# 802.3dj D2.3

## Comment Resolution

## Optical Topics

## 180.9.6.4 TDECQ measurement method

Figure 180-11—Illustration of the TDECQ measurement

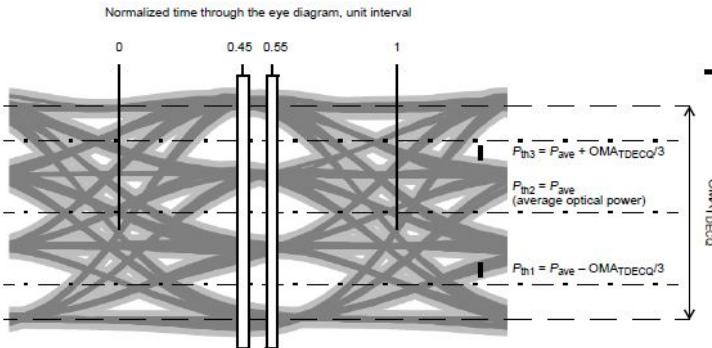
OMA\_TDECQ is used to calculate the threshold power,  $P_{th\_1}$  and  $P_{th\_2}$ , which is set according to the equalized eye diagram as shown in Figure 180-11. OMA\_TDECQ should not be measured at the input of the equalizer.

In the sentence "The TDECQ reference point where OMA\_TDECQ is referenced to and noise is added is at the input of the reference equalizer." it is not clear what these reference points are. Further, the measurement point for OMA\_TDECQ contradicts the text on page 485 line 46 and 488 line 52. If these are intended to be the same point then one or the other locations needs to be corrected. If they are intended to be different, then a different parameter name should be used. Finally, the definition of OMA\_TDECQ should be colocated where it is used, e.g., along with equation 180-1 through 180-3.

Reconcile the measurement points for OMA\_TDECQ or use different parameter names. Define OMA\_TDECQ where it is referenced in equations, e.g., page 483 line 45. Delete the sentence at page 482 line 53. Note that another comment deals with the mention of noise in this sentence.

OMA-TDECQ is measured as defined in 180.9.5 except using waveforms captured at the output of the reference equalizer

Figure 180-10—TDECQ reference equalizer functional model

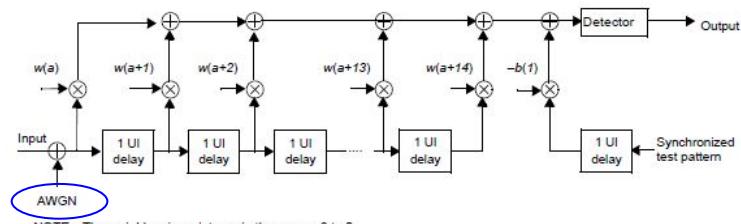
The sentence "The TDECQ reference point where OMATDECQ is referenced to and noise is added is at the input of the reference equalizer." It is not clear which noise this is referring to. It would be good to link the AWGN noise source in Figure 180-10 with sigma\_g. Note that another comment deals with the OMA\_TDECQ in this sentence.

Delete the reference sentence.

Change the sentence to: "G\_th1(y\_i), which represents AWGN at the input to the reference equalizer (see Figure 180-10), is equivalent to a Gaussian probability density function with an RMS value of  $\sigma_G$ , centered around the sub-eye threshold P\_th1."

$G_{th1}(y_i)$ , which represents AWGN at the input to the reference equalizer (see Figure 180-10), is equivalent ...
